ADDENDUM No. 1

TO INVITATION TO BID No. 2022C044

TITLE: ERWWTF EQ Repairs & Structural Retrofits.

Addendum No. 1
November 16, 2022

DWG S2.1AR

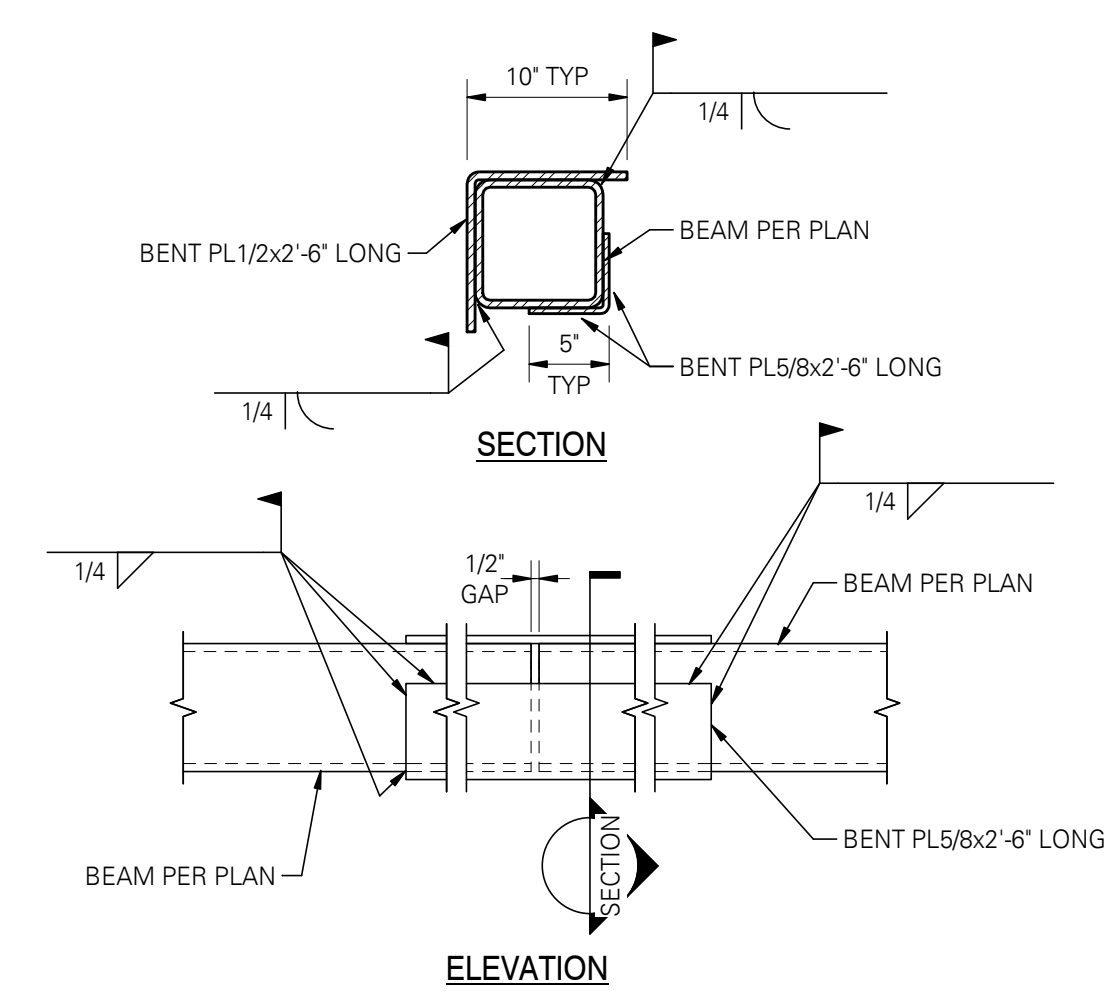
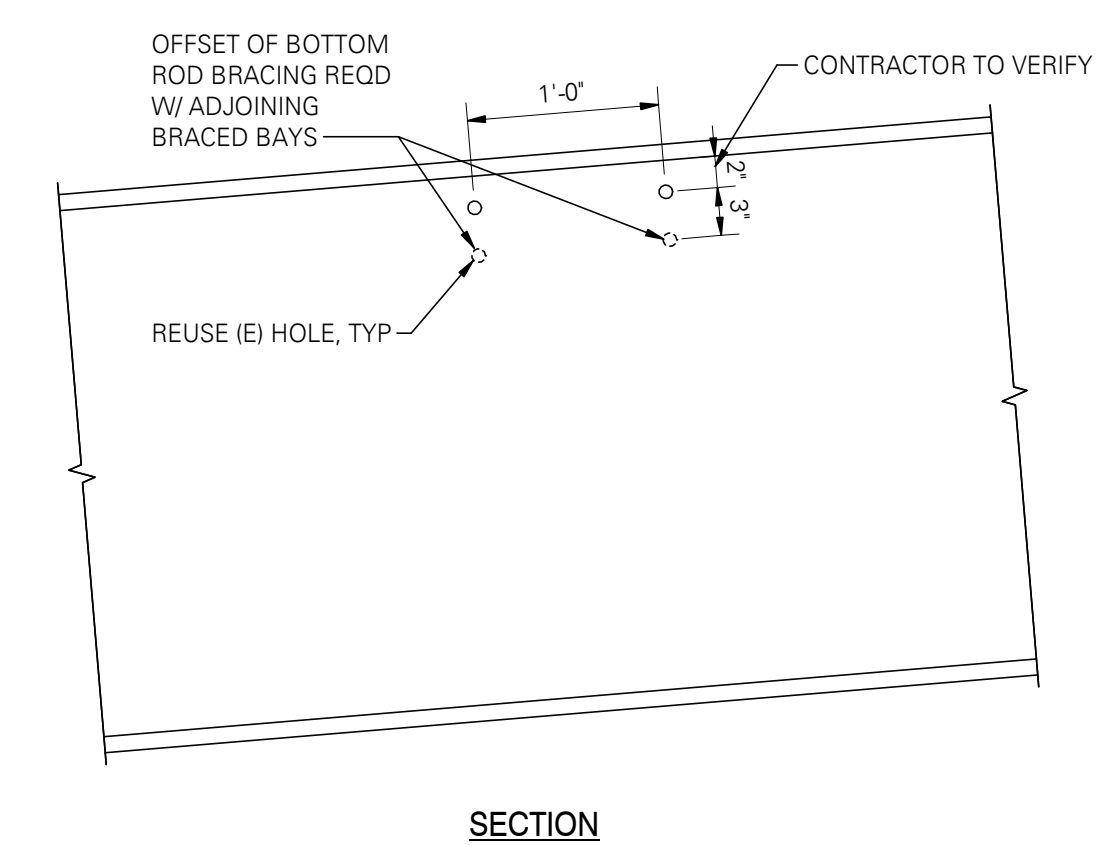
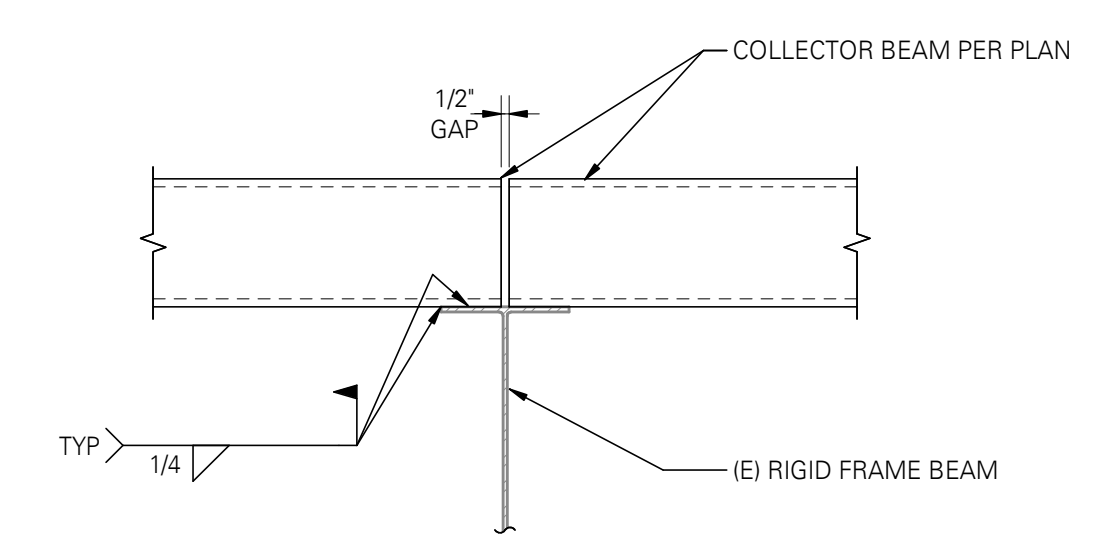
Item 3 – Schedule B	Paid on a UNIT PRICE basis: The price for each shall include full compensation for: Retrofit of structural connection of collector beams to braced framing per Drawing Details S2.1A/8 and S2.1B/8.
------------------------	--
